DART AEROSPACE LTD		Work Order:	140428
Description: Crosstube Assembly		Part Number:	D407-667-145
Inspection Dwg: D407-667-145 Rev: C		Page 1 of 2

DESIGN	40	DART AEROSPACE LTD	
DRAWN	RF	HAWKESBURY, ONTARIO, CANADA	
CHECKED	40	DRAWING NO.	REV. C
MFG. APPR.	40	D407-667-145	SHEET 2 OF 4
APPROVED	40	TITLE	SCALE
DE APPR.	40	CROSSTUBE ASS'Y (407 HIGH FWD)	NTS
DATE	08.11.06	COPYRIGHT © 2002 BY DART AEROSPACE LTD	
THIS DOCUMENT IS PRIVATE AND CONFIDENTIAL AND IS SUPPLIED ON THE EXPRESS CONDITION THAT IT IS NOT TO BE USED FOR ANY PURPOSE OR COPIED OR COMMUNICATED TO ANY OTHER PERSON WITHOUT WRITTEN PERMISSION FROM DART AEROSPACE LTD.

DRAWING NO. D407-667-145	TITLE CROSSTUBE ASS'Y (407 HIGH FWD)	REV. C	DART AEROSPACE LTD ENGINEERING ORDER		D.E.O. NO. D407-667-145-C-1	SHEET NO. SHEET 1 OF 1	SCALE NTS
DRAWN <i>q</i>	CHECKED <i>ASS</i>	MFG. APPR. <i>18</i>	APPROVED <i>WD</i>		DE APPR. <i>11</i>		
DATE 11.07.15	DATE 11.07.22	DATE 11.07.22	DATE 11/07/22		DATE 11.07.21

DRAWING NO. D407-667-145	TITLE CROSSTUBE ASS'Y (407 HIGH FWD)	REV. C	DART AEROSPACE LTD ENGINEERING ORDER	D.E.O. NO. D407-667-145-C-2	SHEET NO. SHEET 1 OF 1	SCALE NTS
DRAWN AJS	CHECKED	MFG. APPR.	APPROVED	DE APPR.		
DATE 12.08.02

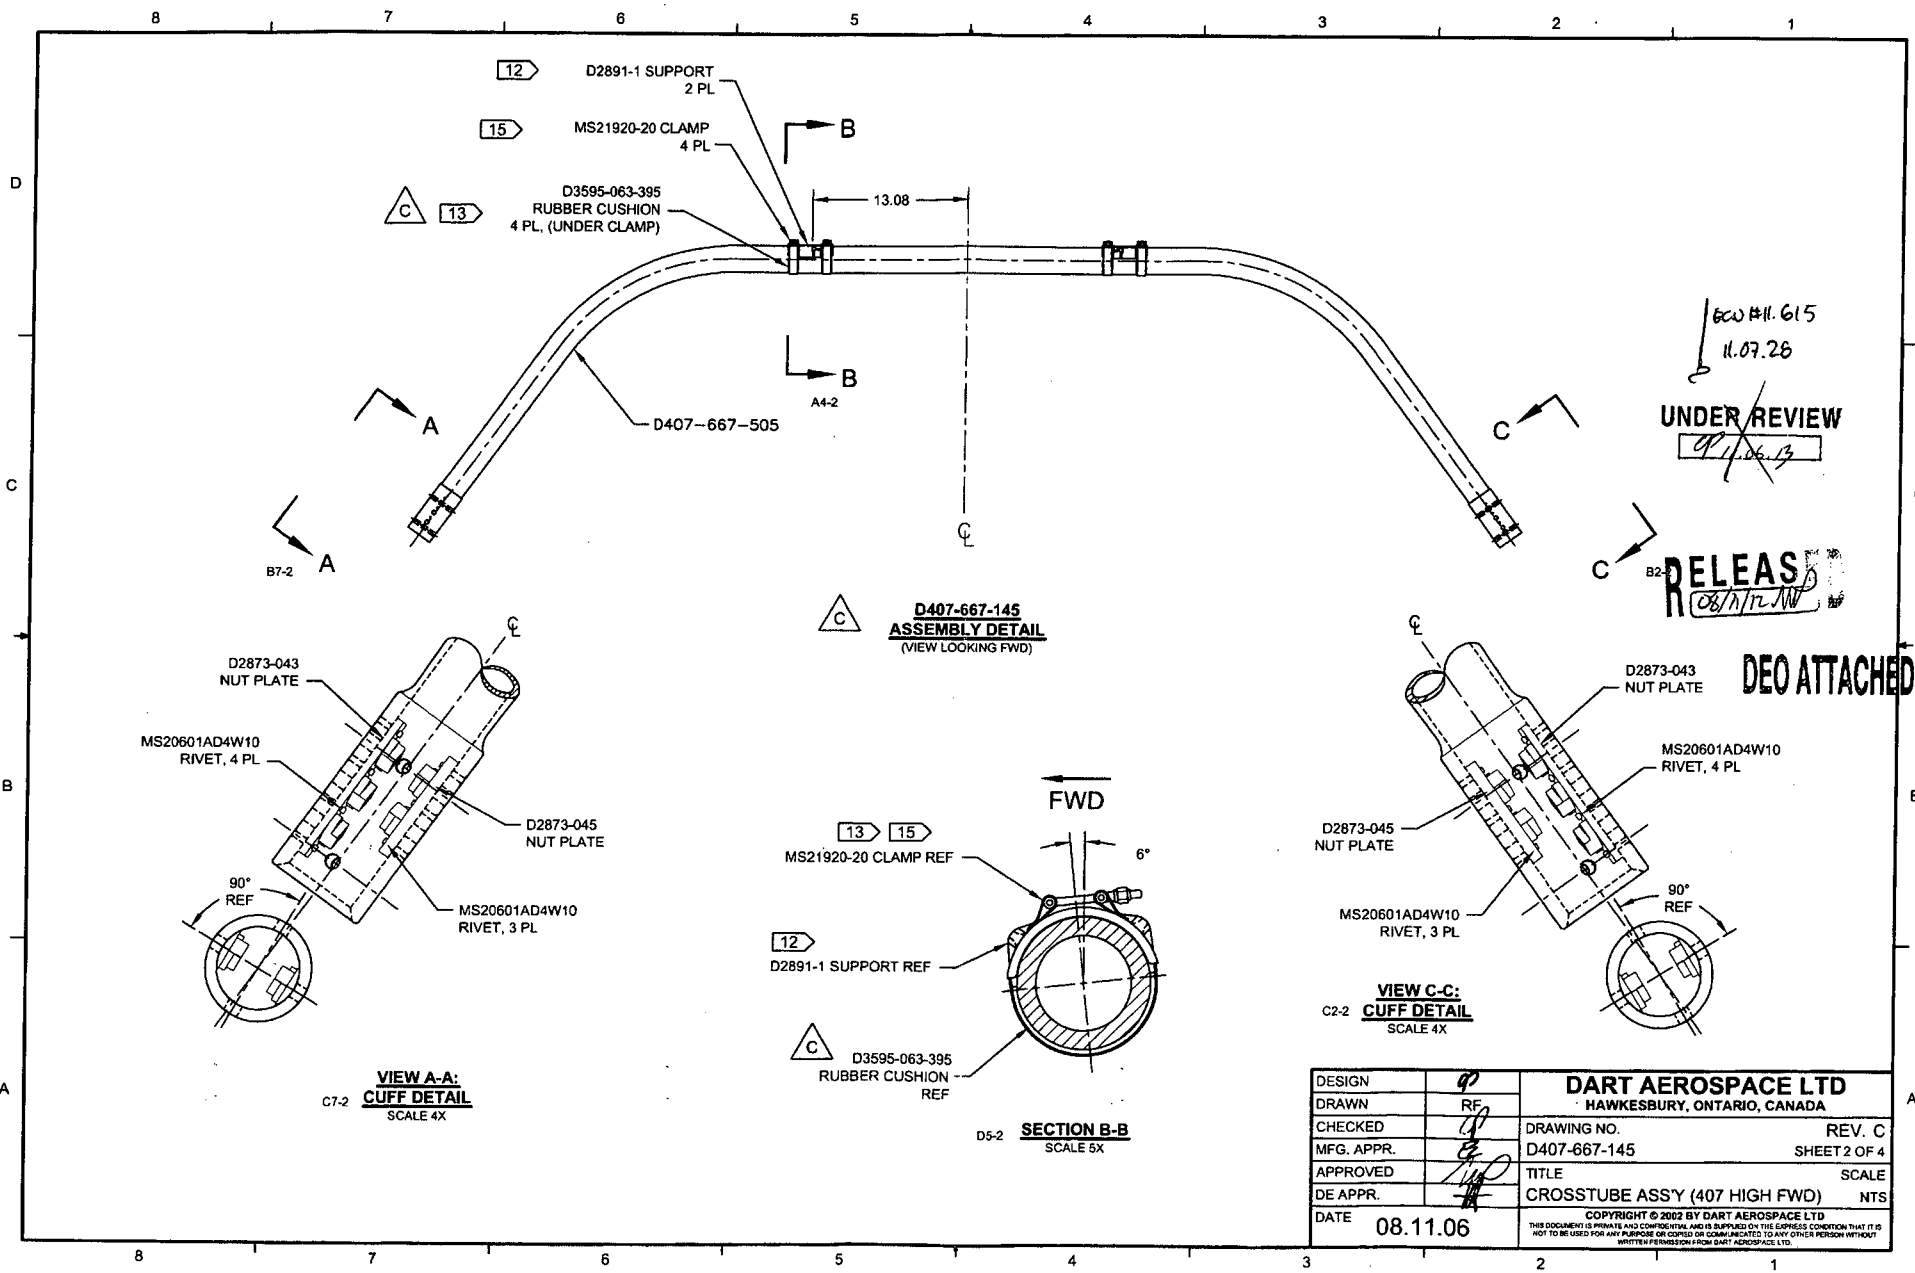
C	REVISE GENERAL NOTES/PART LIST (ZN D7-1); REORGANIZED VIEWS AND REFORMATTED DRAWING TO CURRENT STANDARDS. D3595-063-395 WAS D2856-400-694 (ZN D6-2 & A5-2); REMOVED REF. 7 ADD TOLERANCES (ZN C6-3, C4-3, D2-3); RELOCATED FLAG #6 (ZN A8-3) PER NCR 210; MOVED TURNING DETAIL & UPDATED TOLERANCE TO SHEET 4.	RF	08.11.06
B	ADD HOLES AND NUT PLATES FOR COMPATABILITY WITH BHT/AA SKUDTUBES	PH	05.07.26
A	NEW ISSUE	CP	02.05.08
REV.	DESCRIPTION	BY	DATE
DESIGN	RF	DART AEROSPACE LTD	
DRAWN	RF	HAWKESBURY, ONTARIO, CANADA	
CHECKED	RF	DRAWING NO.	REV. C
MFG. APPR.	RF	D407-667-145	SHEET 1 OF 4
APPROVED	RF	TITLE	SCALE
DE APPR.	RF	CROSSTUBE ASSY (407 HIGH FWD)	NTS
DATE	08.11.06	COPYRIGHT © 2002 BY DART AEROSPACE LTD THIS DOCUMENT IS PRIVATE AND CONFIDENTIAL AND IS SUPPLIED ON THE EXPRESS CONDITION THAT IT IS NOT TO BE USED FOR ANY PURPOSE OR COPIED OR REPRODUCED IN ANY FORM OR BY ANY MEANS WITHOUT WRITTEN PERMISSION FROM DART AEROSPACE LTD

DETAIL P
BONDING STRAP INSTALLATION 2 PL

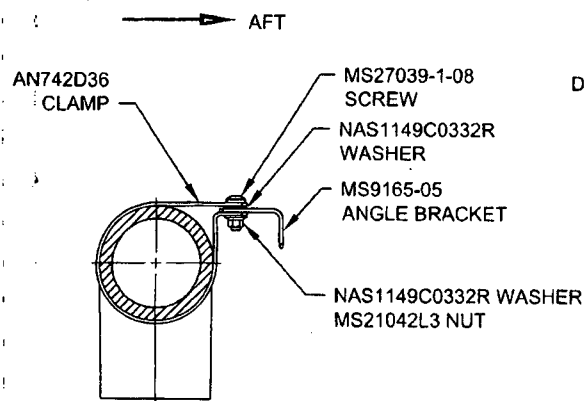
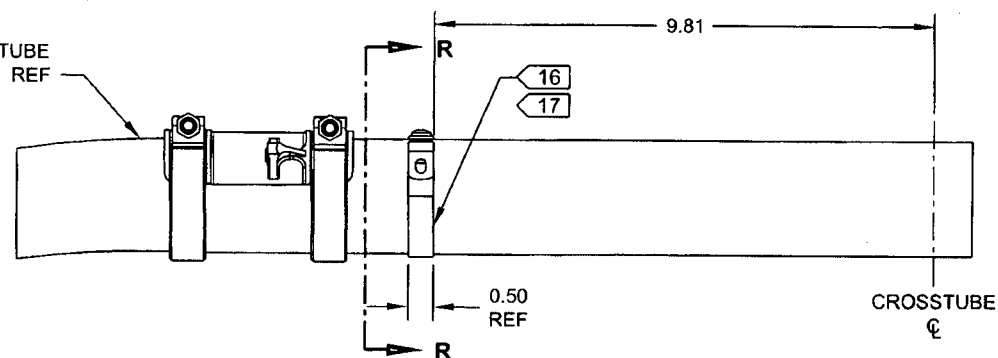
ADD ELECTRICAL GROUNDING STRAP

ITEM	QTY -145	PART NUMBER	DESCRIPTION
1	X	D407-667-145	CROSSTUBE ASSEMBLY (407 HIGH FWD)
10	2	AN742D36	CLAMP
11	2	MS9165-05	ANGLE BRACKET
12	2	MS21042L3	NUT (OR MS21042-3)
13	2	MS27039-1-08	SCREW
14	4	NAS1149C0332R	WASHER (OR AN960C10L)

- 16) MASK AREA UNDER CLAMP PRIOR TO PAINTING
- 17) SEAL EDGES WHERE AN742D36 CLAMP MEETS WITH THE CROSSTUBE USING SIKAFLEX-241/-291 OR MIL-S-8802 CLASS B2 OR PROSEAL 890 SEALANT
- 18) PERFORM RESISTANCE CHECK TO ENSURE MAX RESISTANCE IS 10 MILLIOHMS
